SOUTH DUBLIN COUNTY COUNCIL'S PLANNING AUTHORITY'S REPORT TO AN BORD
PLEANALA ON APPLICATION FOR

SUBSTITUTE CONSENT UNDER SECTION 261A

AT BEHAN'S QUARRY WINDMILL HILL, RATHCOOLE

ACCOMPANIED BY A REMEDIAL EIAR AND A SCREENING REPORT TO INFORM THE
REMEDIAL APPROPRIATE ASSESSMENT

Figure 4.1

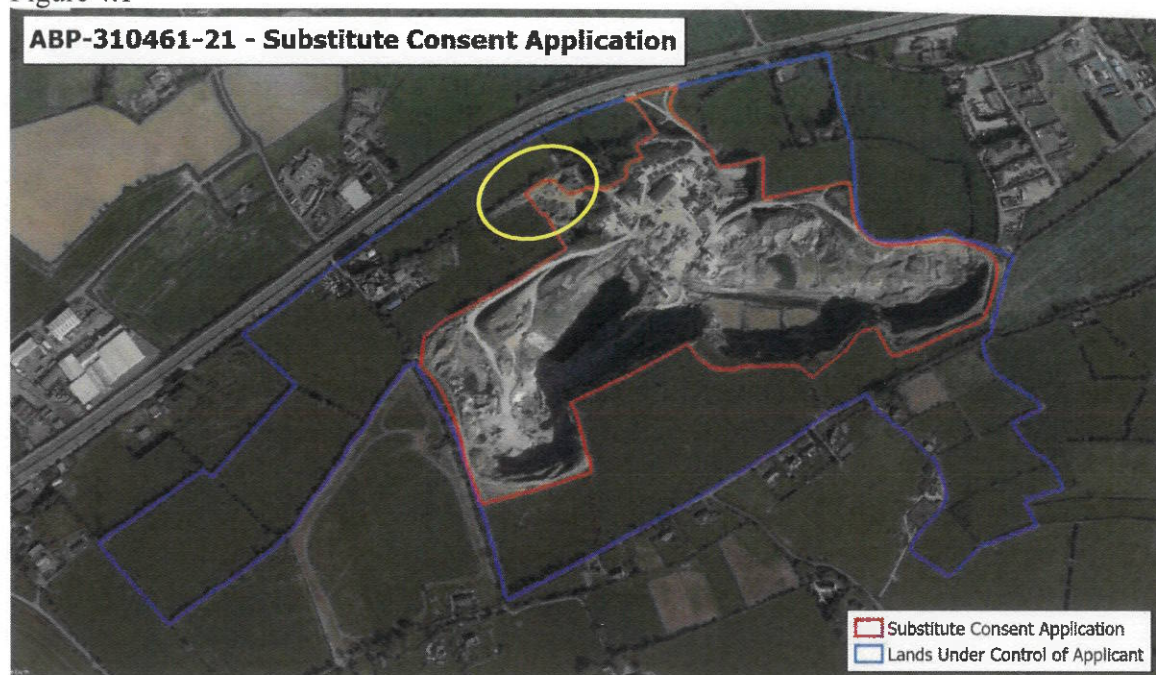
- 4.1 The Planning Authority notes the red line and blue lines as delineated on Site Location Map Project No. 20137776 Drawing No. 02 and would like to draw the Board's attention to works that may be carried out on lands outside of the red line and within the blue line to the north-west of the site. Refer land circled yellow, Figure 4.1.

Figure 5.1

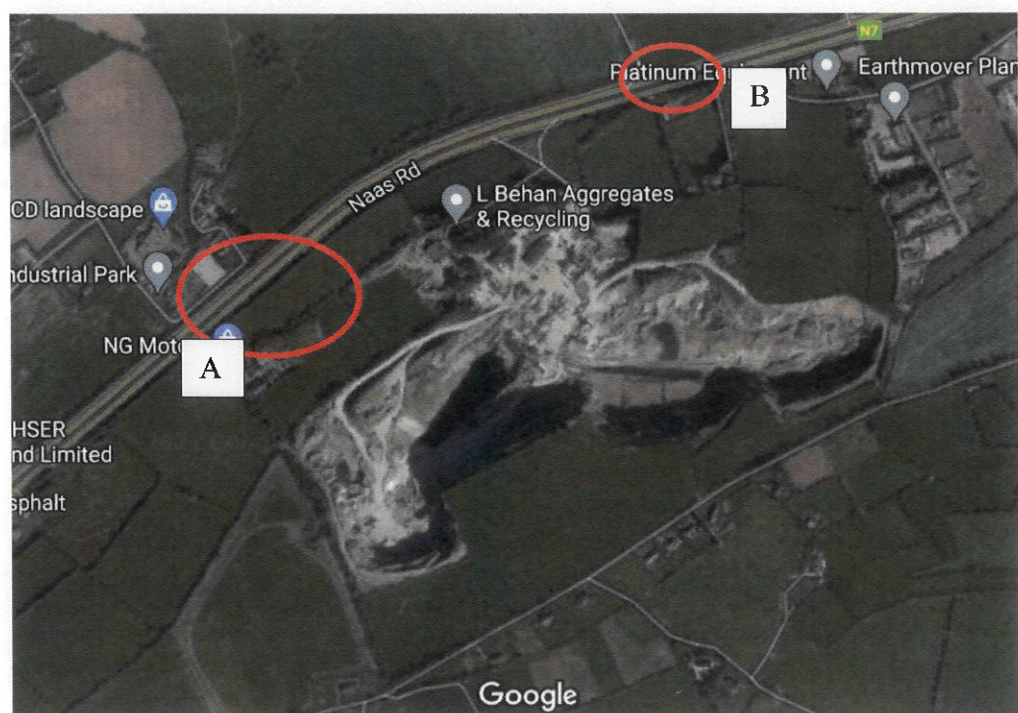
- 5.2** The Planning Authority also notes and would like to draw the Board's attention to commercial activities that are alleged to be taking place to the north and west of lands outlined in blue within the ownership of the applicant. [Circled and labelled A on Figure 5.1]. The lands take access from the Naas Road (N7). No planning history can be traced to these lands and a recommendation has been sent to South Dublin County Council's Enforcement department to investigate these works and commercial uses on rural zoned lands.

- 5.3** The Planning Authority also notes alleged unauthorised development, works and uses that have taken place on lands outlined in blue located to the north and east of the overall landholding. [Circled and labelled B on Figure 5.1] The site is located off the N7 (with an agricultural entrance in place). The development constructed on site appears to take access off the historic Naas Road, now cul-de-sac'd. No planning history can be traced to these lands and a recommendation has been sent to South Dublin County Council's Enforcement department to investigate these works and uses on rural zoned lands.
